SUBJECT: Capital Project 4466, Building E Utility Plant Renovations and Improvements
Addendum #5- Bid Due Date and Bid Question acceptance deadline extensions,
responses to Bid Questions, and Modification of Project Specification -
(Addendum #5)

ADDENDUM #5

COUNTY OF ROCKLAND FACILITIES MANAGEMENT BLDG. A., 2 nd FLOOR, 50 SANATORIUM RD, POMONA, NY 10970 PHONE: 845-364-2958 / FAX: 845-364-3810		PAGE: 2
CAPITAL PROJECT NUMBER: 4466 PROJECT: Building E Utility Plant Renovations and Improvements	BID NUMBER: RFB-RC-2021-4466-001

Addendum #5

CHIMNEY LINER RISER
SCALE: NONE

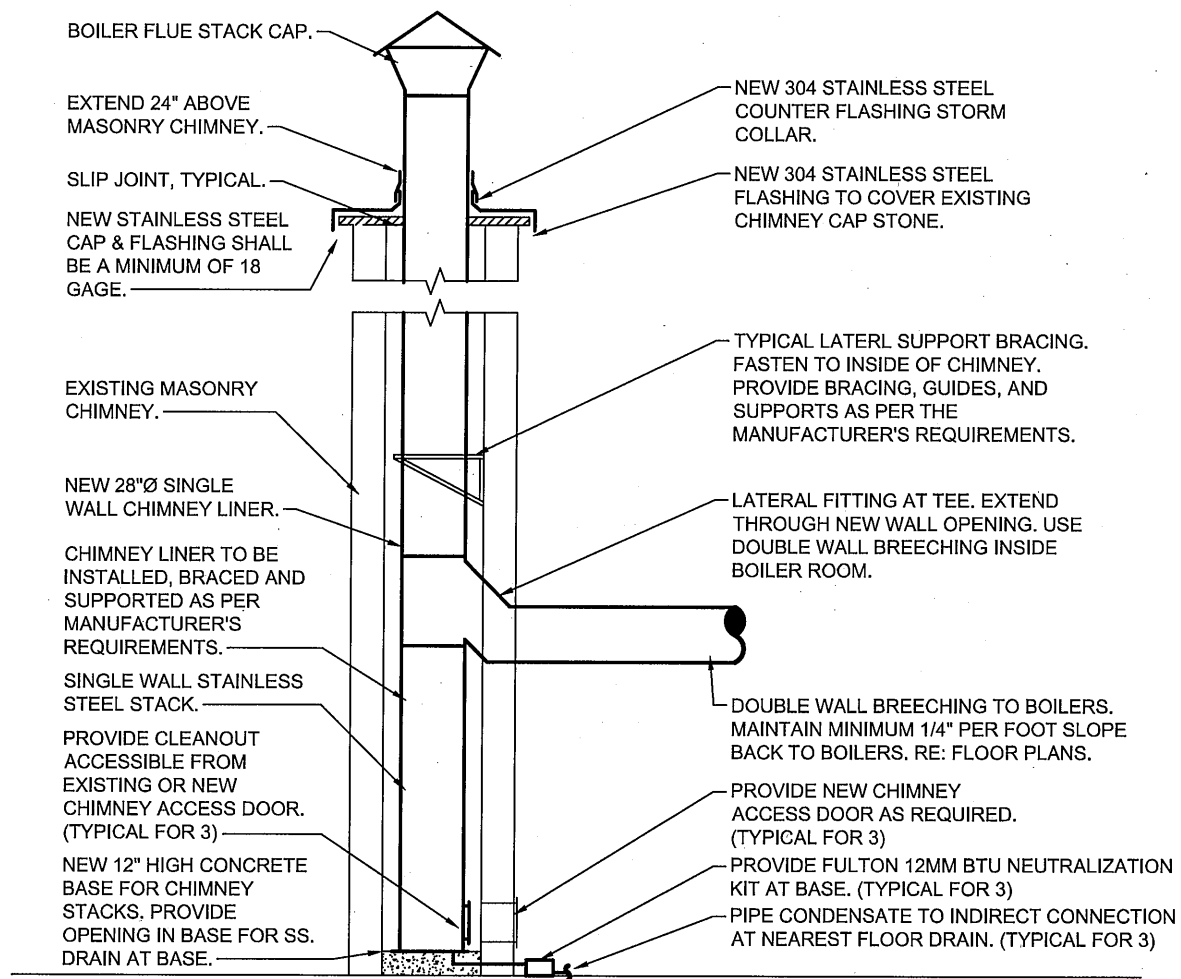
2. Drawing M6.1 - Delete Equipment Note #2
3. Drawing M 7.2 Detail #5 Chimney liner Riser shall be replaced with the attached detail.

NOTES:
1. ARRANGEMENT IS TYPICAL FOR ALL (3) CHIMNEY STACKS.
